114 ADELAIDE ROAD, NEWTOWN

TRAFFIC DESIGN STATEMENT

Proposed Hotel – 114 Adelaide Road – Wellington Section 92 Response

Image 01: Showing car positioning within the private driveway adjacent Adelaide Road.

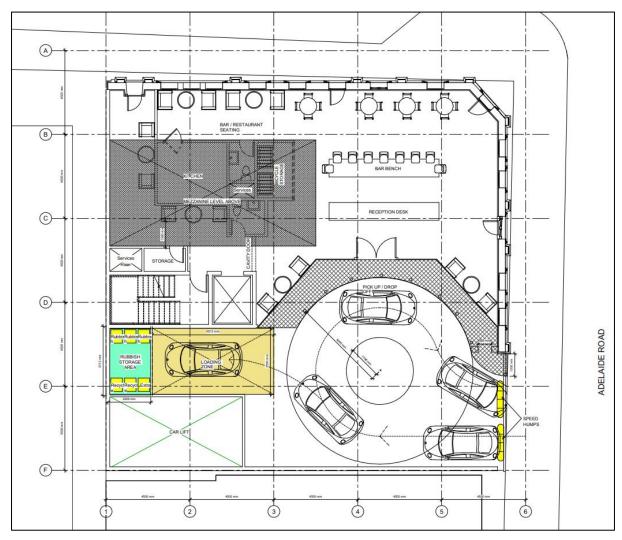
In response to the resource consent submission, Wellington Council submitted an RFI letter raising concerns on how vehicles will be managed on the site, as well as what mitigation measures will be implemented for vehicles existing the site at peak times. A traffic survey was also requested for hotel car parks to determine the estimated trip rate for the proposed hotel.

- How will vehicles be managed and what mitigation measures will be implemented for vehicles exiting the site at peak times when there is potential conflict between pedestrians, cyclists and vehicles? Mitigation measures may include the use of a speed hump, mirrors, signage or restricting vehicle movements at peak times i.e 7am – 9am.
- 2. Provide traffic survey of vehicle trip rate from hotel car parks what is the estimated trip rate for the proposed hotel between 7am and 10am. Preferably include a breakdown to 30 minute intervals.
- 4. Provide further details on how you will ensure vehicles will not queue on Adelaide Road, waiting to enter the site to use valet parking.
- 5. Provide details on the valet parking operation to include vehicle manoeuvring, passing areas and queuing space.
- 6. How will conflict between vehicles entering the site and exiting the site be managed?

Speed humps have been included at the vehicle entrance to assist controlling the speed of cars entering and exiting the site. Reducing speed at the site boundary will also help protect pedestrians along the footpath, and a generous opening has been provided for the vehicle entrance to increase pedestrian/street visibility at Ground Level.

Once inside the building, cars will follow the pathway of the roundabout to the hotel entrance. The loading bay for rubbish collection is also accessible via the roundabout and could be used to temporary parking when rubbish is not being collected.
